## ADDENDA NO. 2

- A. Project Name: **Orange High School Phase 2 Renovations.**
- B. Owner: **Orange County Schools.**
- C. Architect: **CRA Associates, Inc.**
- D. Architect Project Number: **2231-OHS.2.**
- E. Date of Addendum: **January 24, 2025.**

2 Renovation Plan - Field House  
A2.4 Scale: 1/8" = 1'-0"

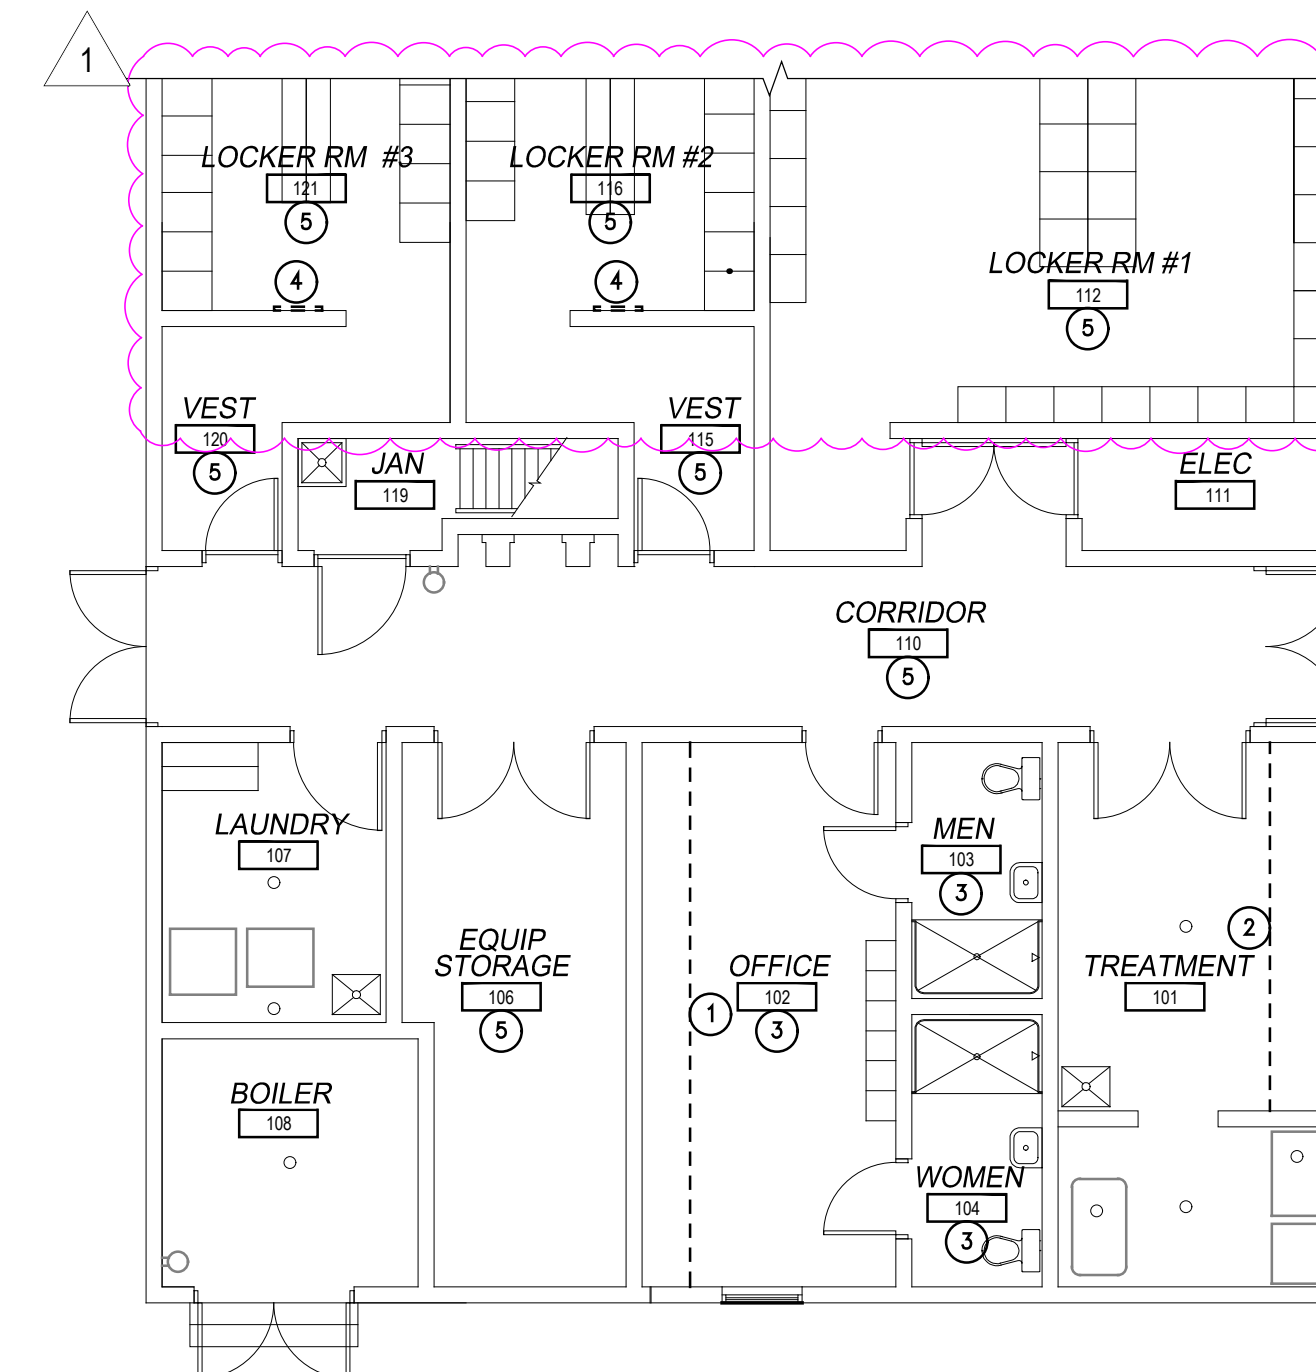
- A. This Addendum includes the following attached Documents and Specification Sections:
  - 1. Document “Form of Proposal,” (reissued).
    - a. Bidders are to use this Form in place of the Form included in the Project Manual and are reminded that it shall be accompanied by the attachments stipulated in the “Form of Proposal” and the “Notice to Bidders.”
- B. This Addendum includes the following attached Sheets:
  - 1. Architectural Sheet A2.4 – Field House Demolition and Renovation Plans, dated January 9, 2025, (reissued).
